72+COLLINS DEVELOPMENT

CITY OF MIAMI BEACH
DESIGN REVIEW BOARD

MARCH 2, 2021

72 COLLINS HOTEL & CONDOMINIUM
MIAMI BEACH, FL

ELEVATION EAST CORNER FACADE - PHASE 1

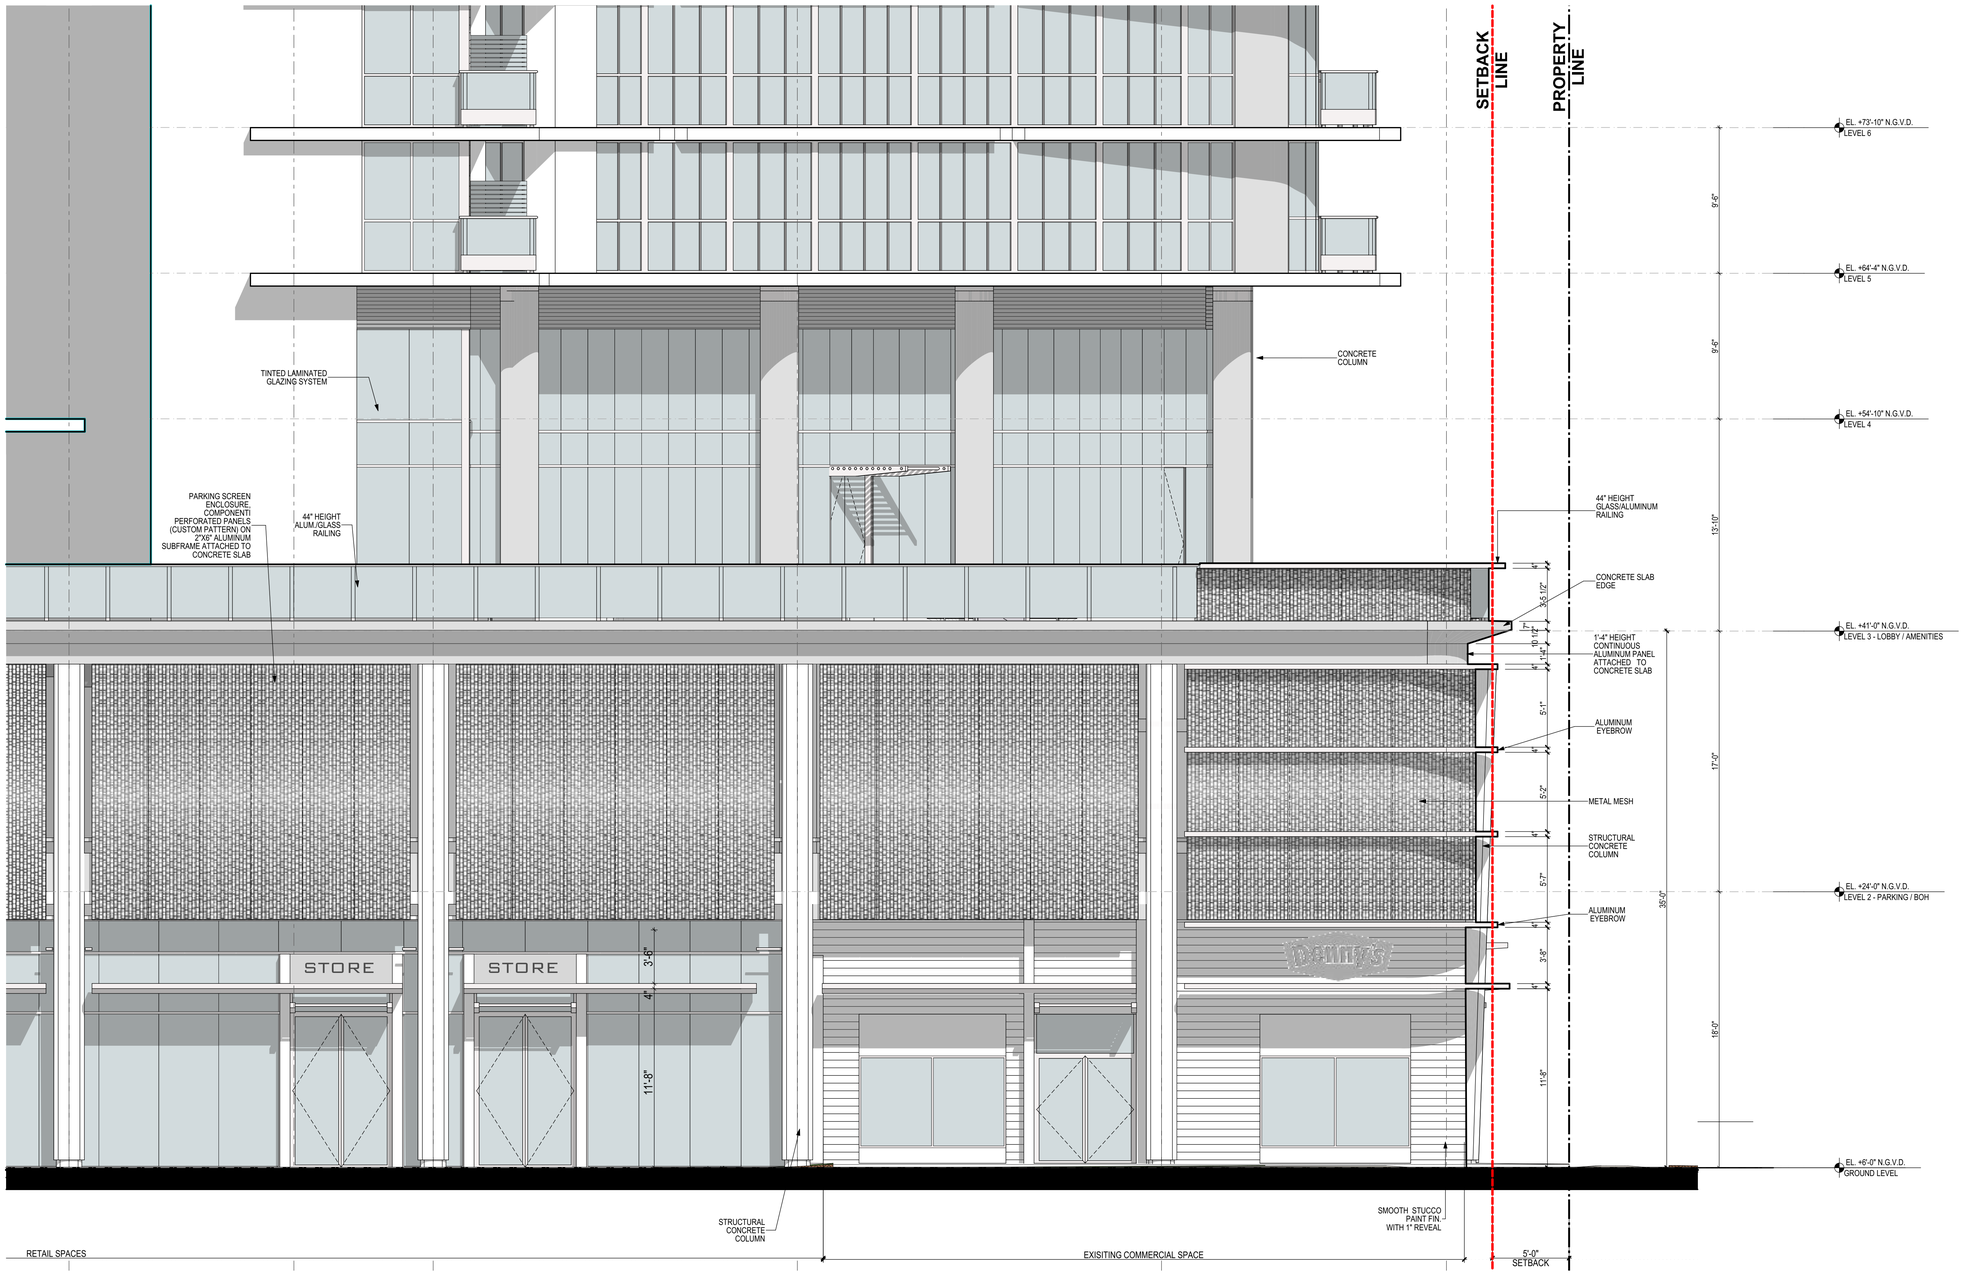
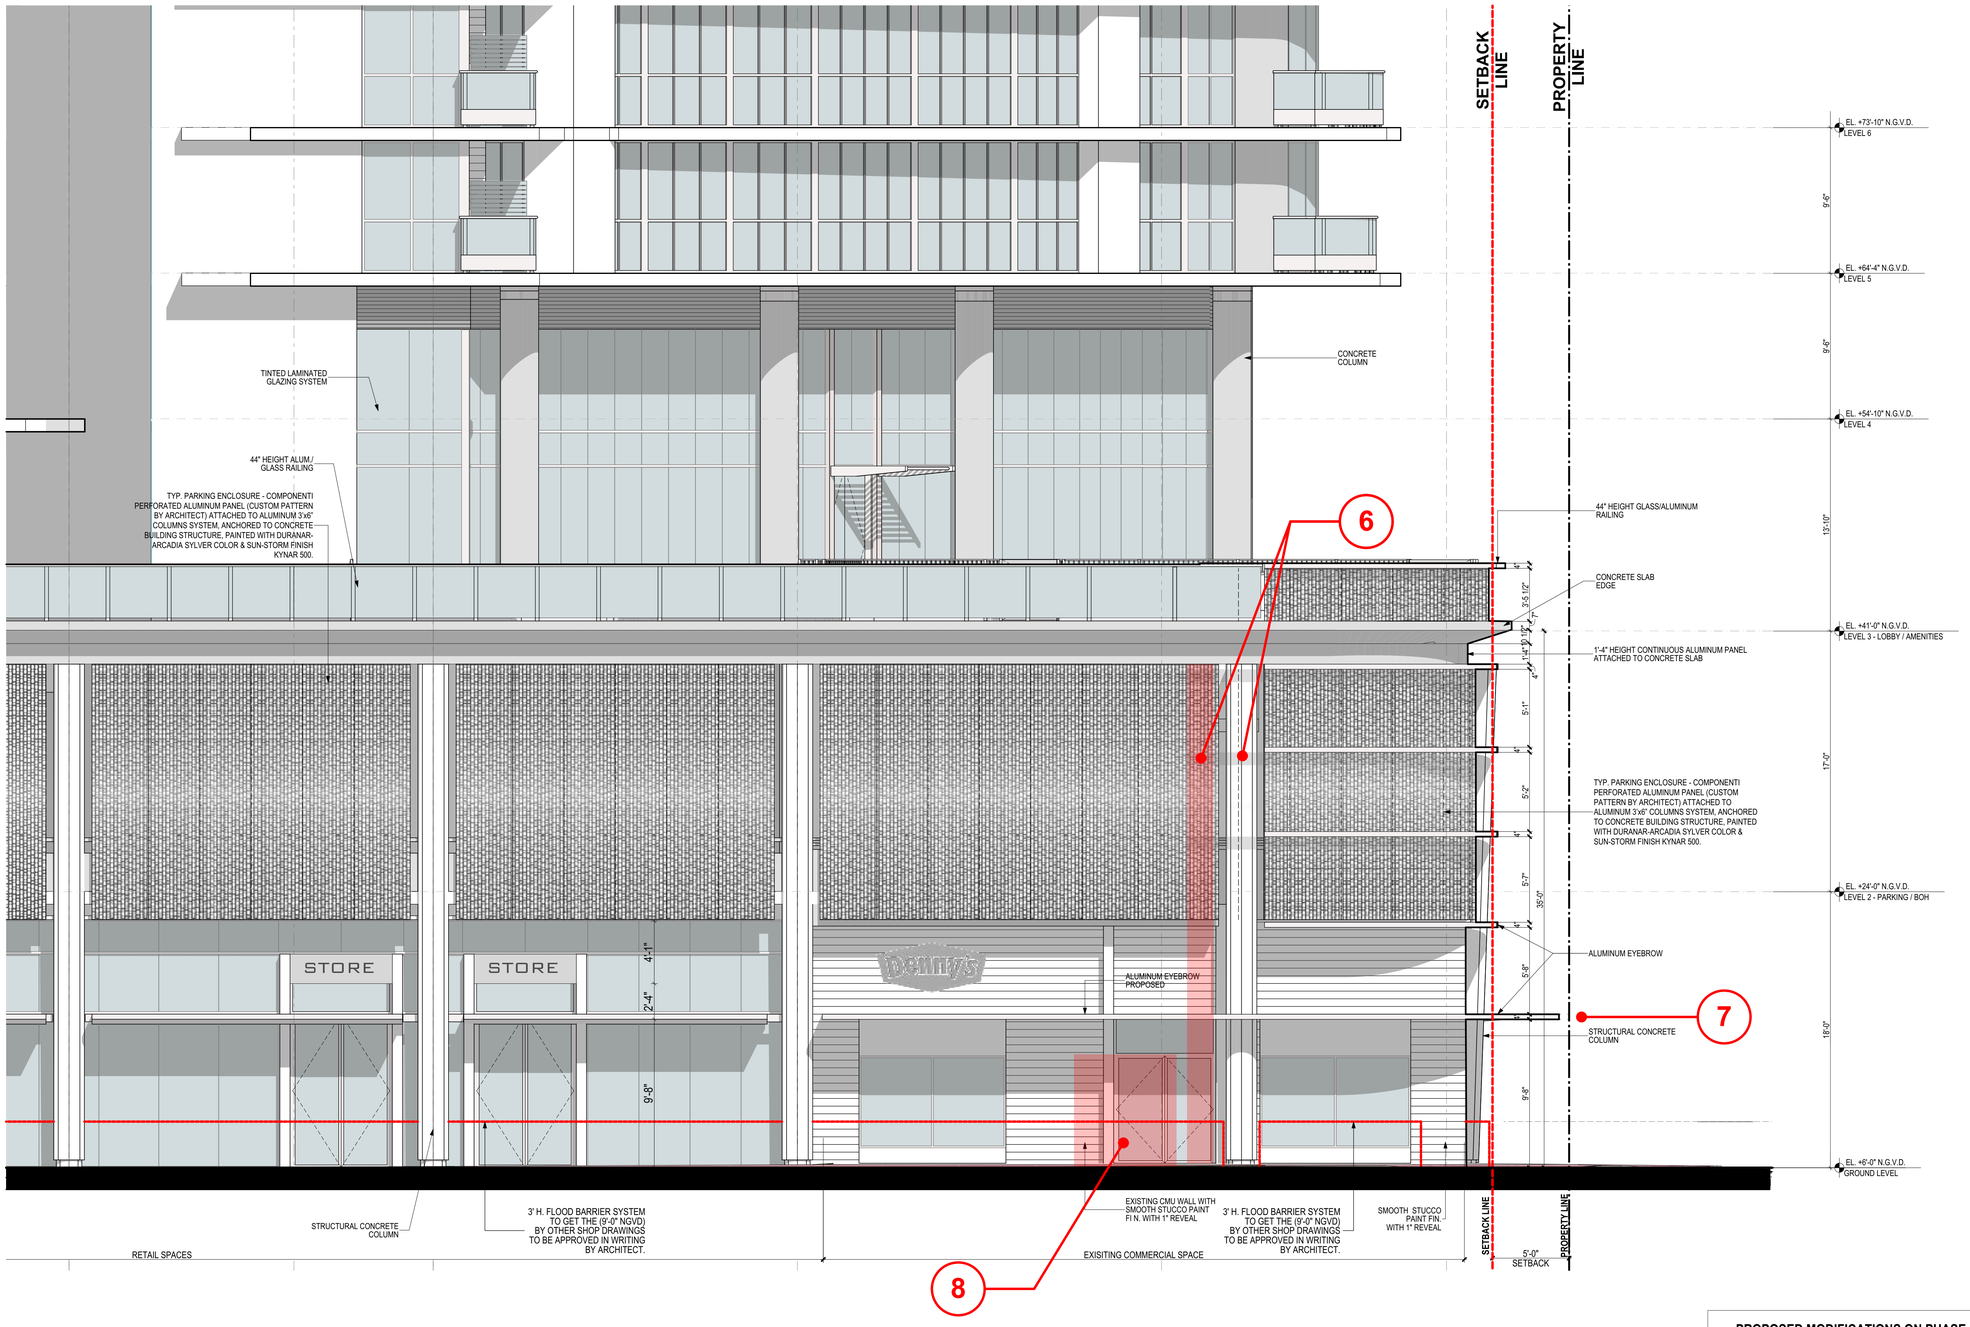
PROPOSED MODIFICATIONS ON PHASE 1

6.	COLUMN RELOCATION
7.	ALUMINUM AWNING/EYEBROW EXTENDED TO MATCH FOOTPRINT OF EXISTING CONSTRUCTED AWNING
8.	RETAIL DOOR RELOCATION

ELEVATION EAST CORNER FACADE - PHASE 2

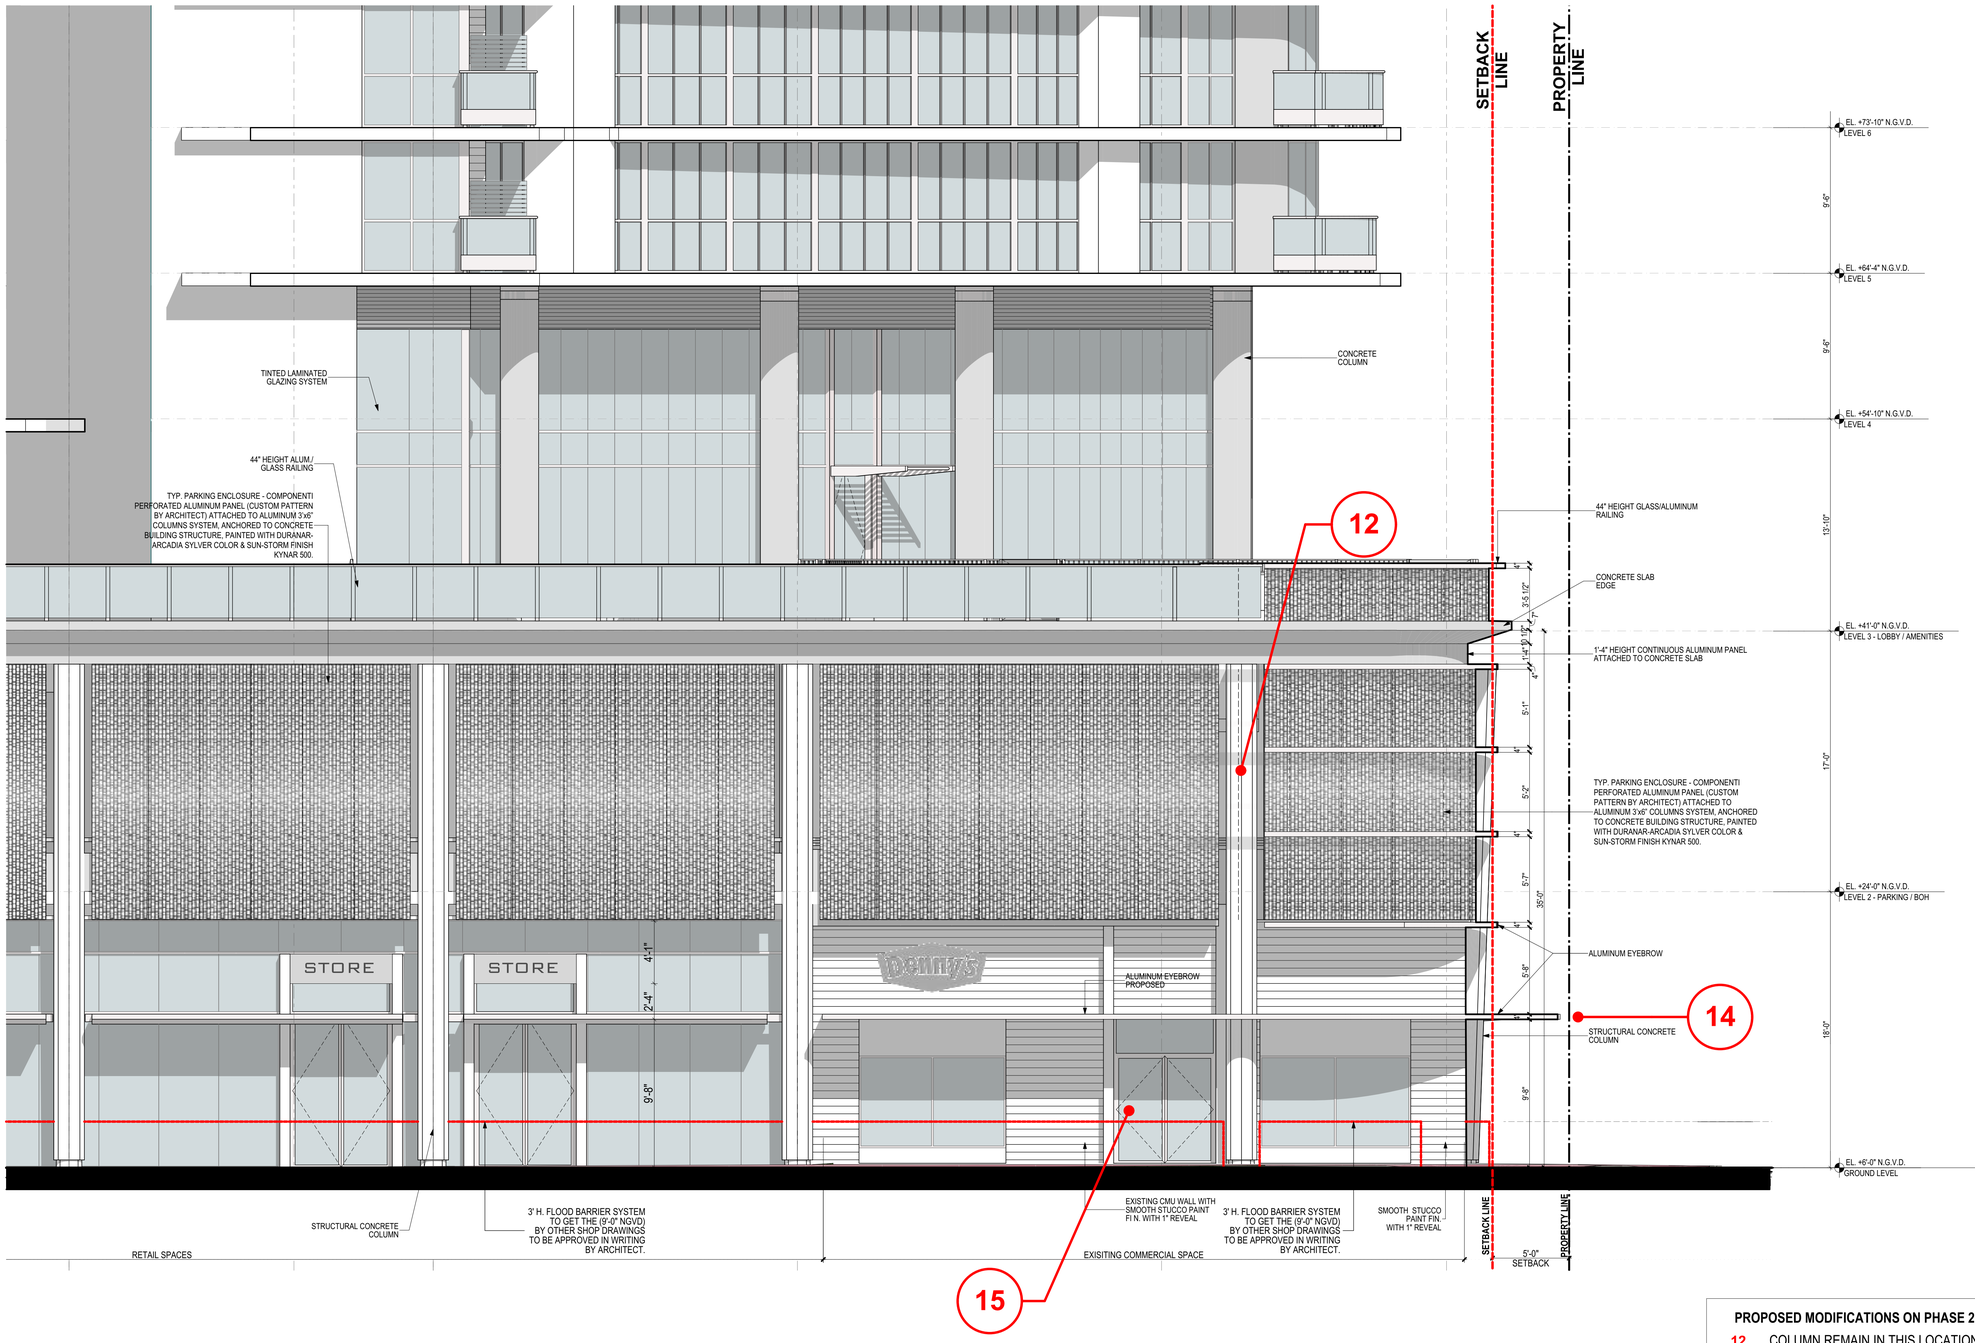
PROPOSED MODIFICATIONS ON PHASE 2

12.	COLUMN REMAIN IN THIS LOCATION
14.	ALUMINUM AWNING/EYEBROW DIMENSIONS REMAIN
15.	RELOCATION RETAIL DOOR

PARTIAL SECTIONS - ADDITIONAL PARKING

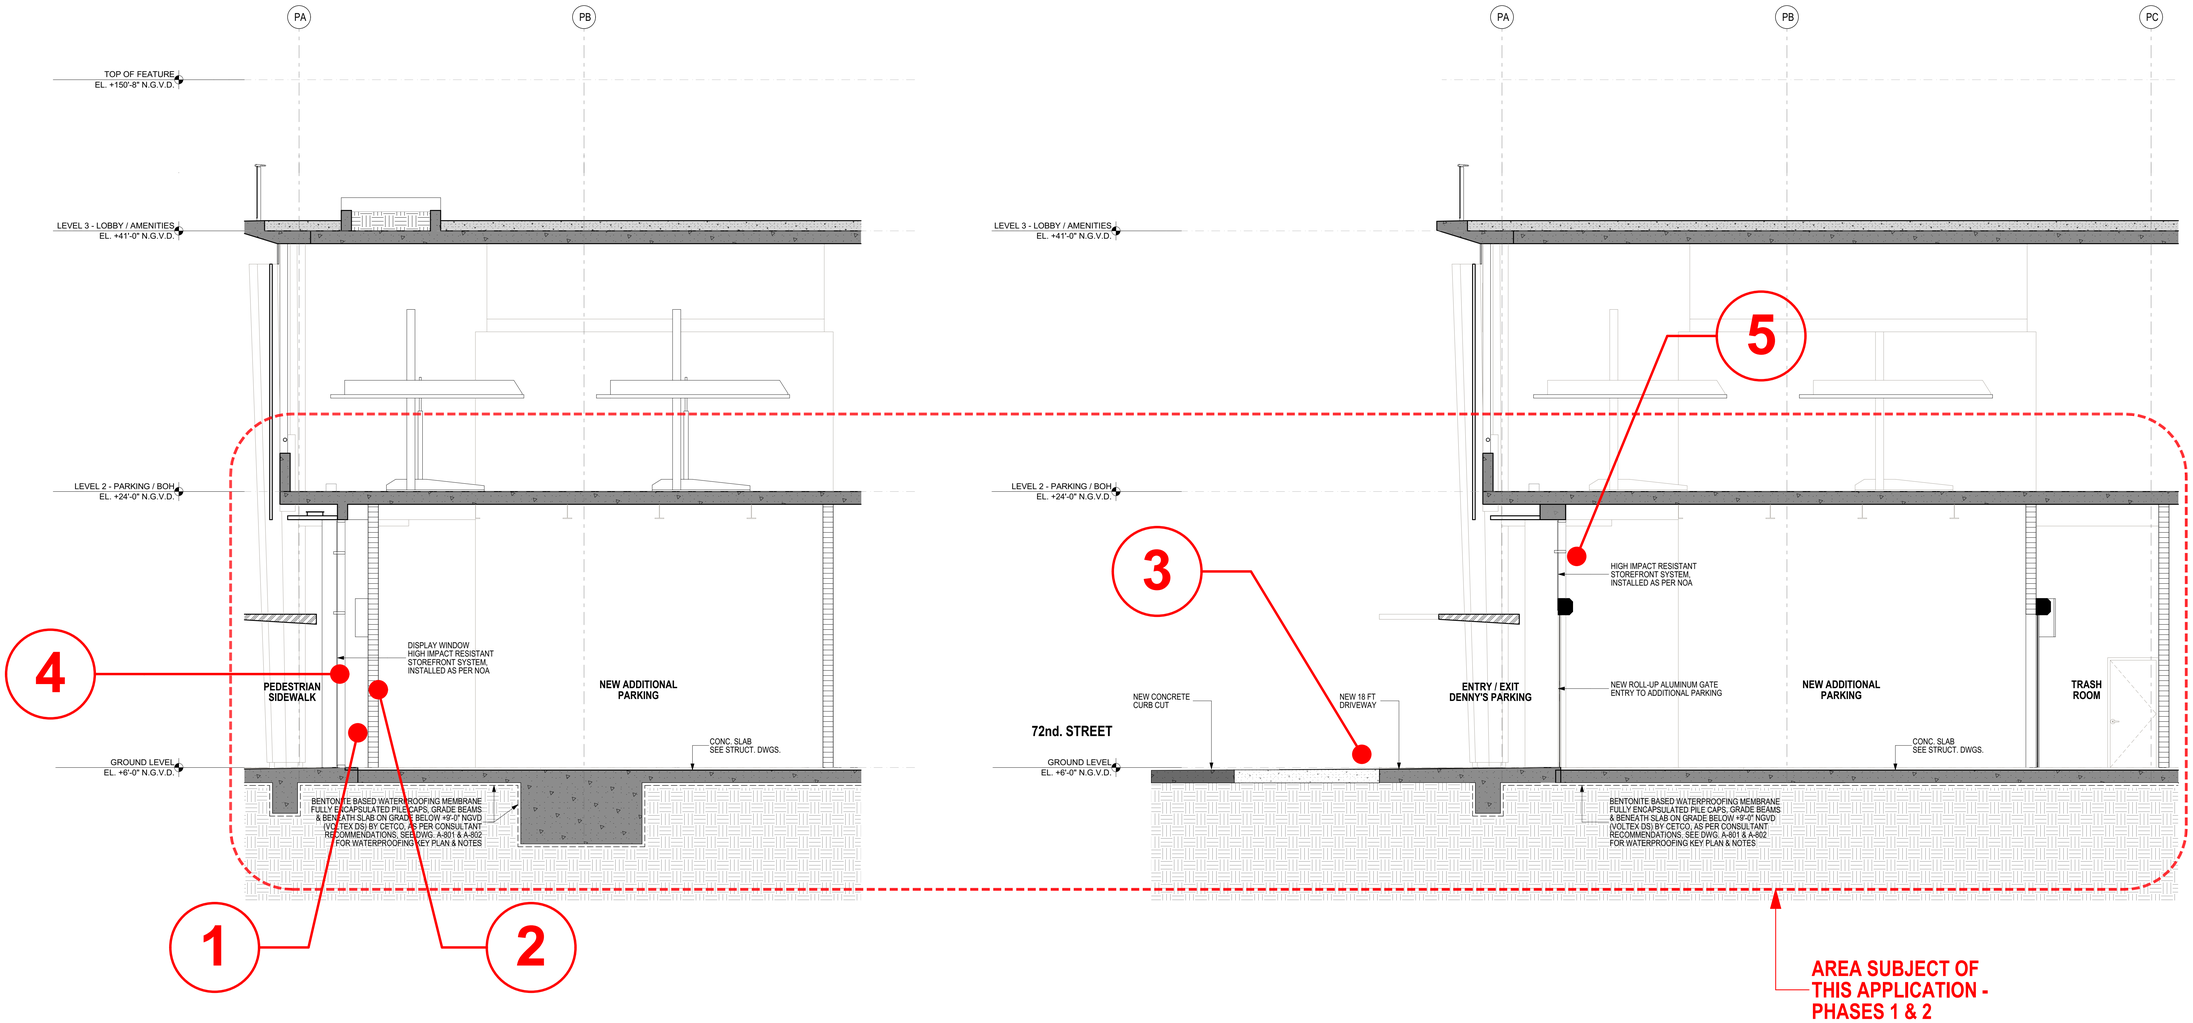
1. SEC. 142-745 (e)(2)(b). EXCEPT WHERE REQUIRED FOR DRIVEWAYS AND UTILITY INFRASTRUCTURE, THE GROUND FLOOR SHALL CONTAIN HABITABLE SPACE WITH A MINIMUM DEPTH OF 50 FEET FROM BUILDING FACADE. **2 FT PROVIDED.**

2. SEC. 142-745 (e)(2)(e). GROUND FLOOR AND SURFACE PARKING SHALL SETBACK A MINIMUM OF 50 FEET FROM THE BUILDING FACADE AND BE CONCEALED FROM VIEW FROM THE CLEAR PEDESTRIAN PATH. **2 FEET PROVIDED.**

3. SEC. 142-745 (e)(3). DRIVEWAYS AND VEHICLE ACCESS TO OFF-STREET PARKING AND LOADING SHALL BE PROHIBITED ON CLASS A FRONTAGE, UNLESS IT IS THE ONLY MEANS OF EGRESS TO THE SITE. **ONE DRIVEWAY PROVIDED ON 72 STREET, WHIS IS A CLASS A FRONTAGE.**

4. SEC. 142-745 (a)(8)(b). FRONTAGE FOR COMMERCIAL, HOTEL, AND ACCESS TO UPPER LEVEL FRONTAGE SHALL CONTAIN A MINIMUM OF 70 PERCENT CLEAR GLASS WINDOWS WITH VIEWS INTO HABITABLE SPACE. **21.56 % PROVIDED.**

5. SEC. 142-745 (a)(10)(a). PARKING FACILITIES SHALL BE ENTIRELY SCREENED FROM VIEW FROM PUBLI RIGHTS-OF-WAY AND CLEAR PEDESTRIAN PATHS.
